ADDENDUM NO. 1
SEWER SYSTEM IMPROVEMENTS
CONTRACT 17-01
MORNINGSIDE DRIVE 8-INCH FORCE MAIN
CHAPEL HILL, TENNESSEE
WAUFORD PROJECT NUMBER 2034
CDBG PROJECT NO. 11132

Date of Addendum: Friday, June 22, 2018
Bid Opening: Thursday, June 28, 2018, 2:00 P.M. Central Time

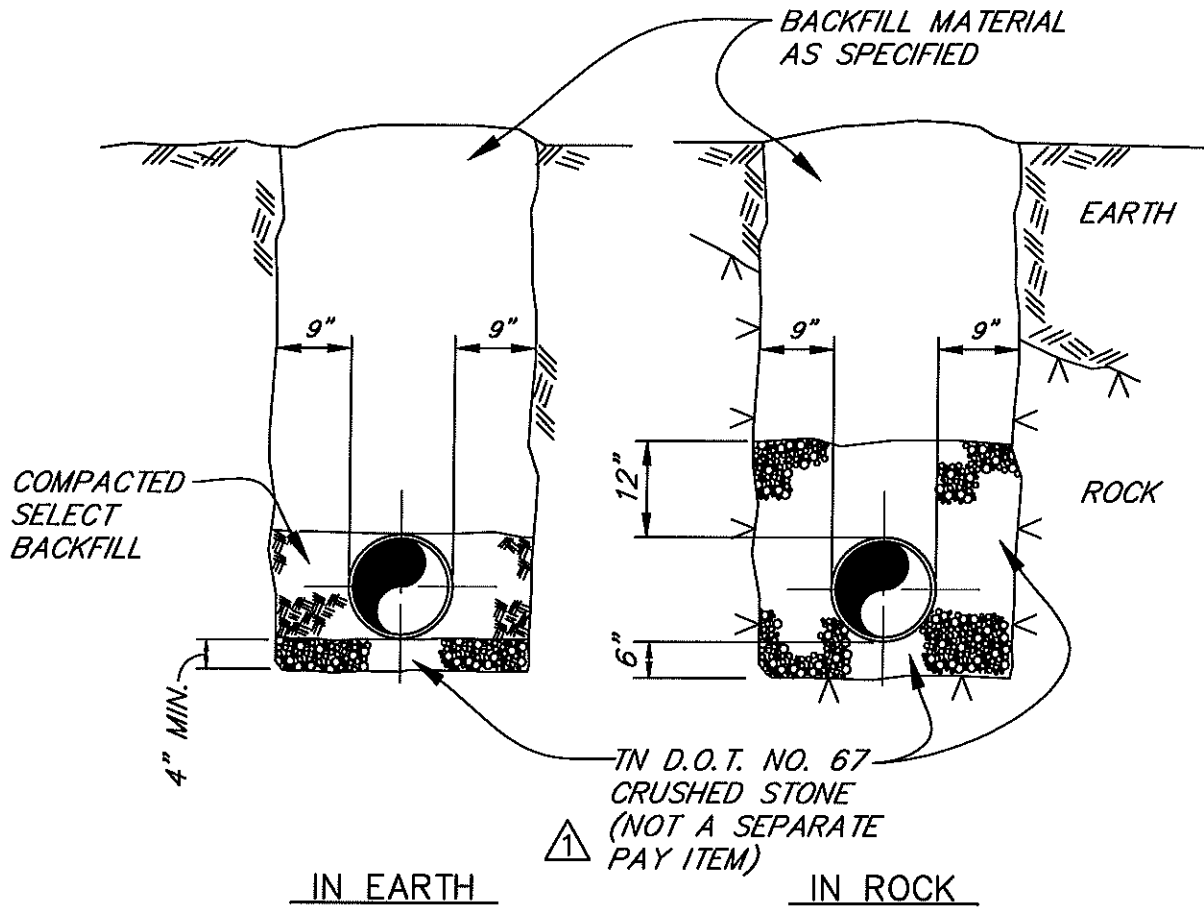
5. Plans, Sheet 15:

Modify as shown on the attached 8 ½" x 11" sheet.

STANDARD FORCE MAIN BEDDING
